**COAL ASH IMPOUNDMENT
SITE ASSESSMENT DRAFT REPORT**

**6th Street Power Generating Station
Alliant Energy
Cedar Rapids, Iowa**

KLEINFELDER PROJECT NUMBER 118953-4

May 2, 2012

Photo 6 – Inlet Pipe into Ash Pond 2
May 24, 2011 NPDES# IOWA-5715109

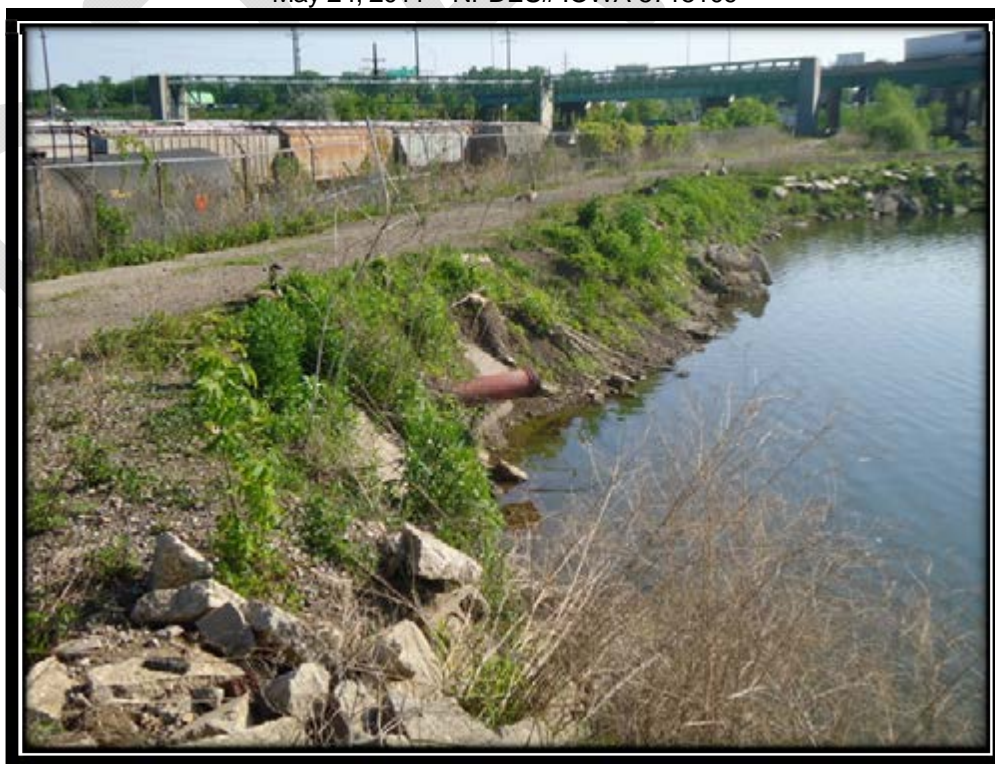
Inflow into Ash Pond 2 occurs through a metal sluice pipe that discharges slurry into the southwest corner of the pond, as well as stormwater runoff that flows naturally into the pond. Flow into the pond is regulated by pumping operations at the plant. The inlet sluice pipe was not operational during the assessment, and showed signs of slight corrosion. However, the sluice pipe appeared that it would operate as intended at the time of assessment. Photos 6-8 at the end of this section show the condition of the impoundment inlet.
